Attachment 4 Q & A

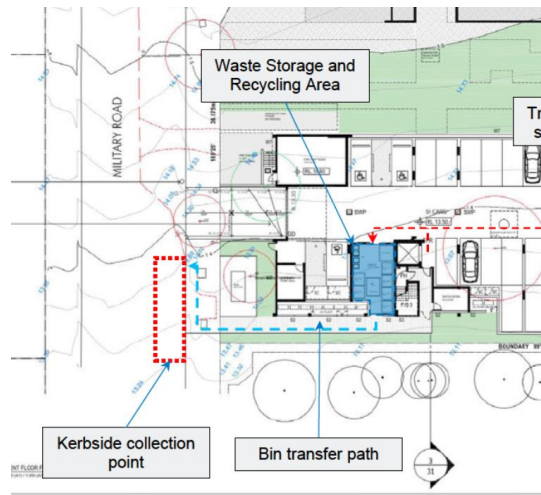
- *Access to basement for waste collection of large skip bin, noting driveway profile and weight of bins when full*

The parking area is partially cut, but is not a traditional basement car park. There is minimal fall from the street to the finished levels of the car parking area. The bins are proposed to be wheeled along the path of travel to the south of the driveway (shown in blue arrows below), which is generally flat and suitable for this purpose.

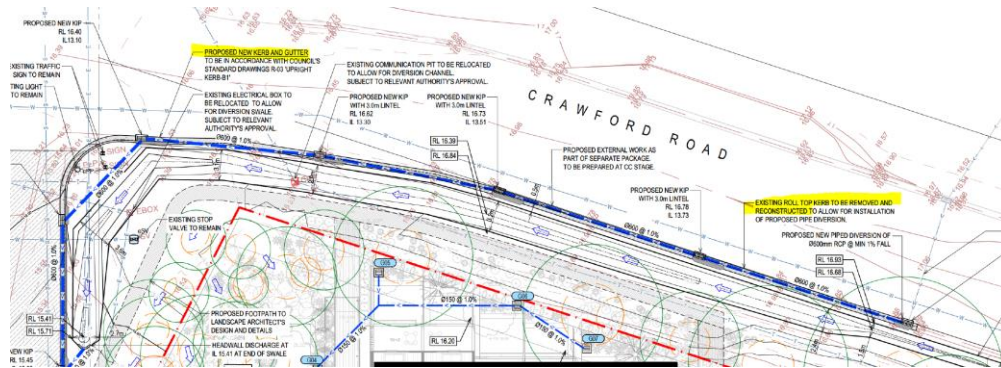
- *Adequacy of proposed management around the buildings, including prevention of over topping and flooding*

The stormwater swales around the building are designed for 1%AEP Stormwater Events which is Council's highest design standard.

If more extreme events do result in overtopping, it is noted that the overtopping would be into the lowest level, which is carparking hard stand with suitable drainage so minimal negative implications are anticipated.
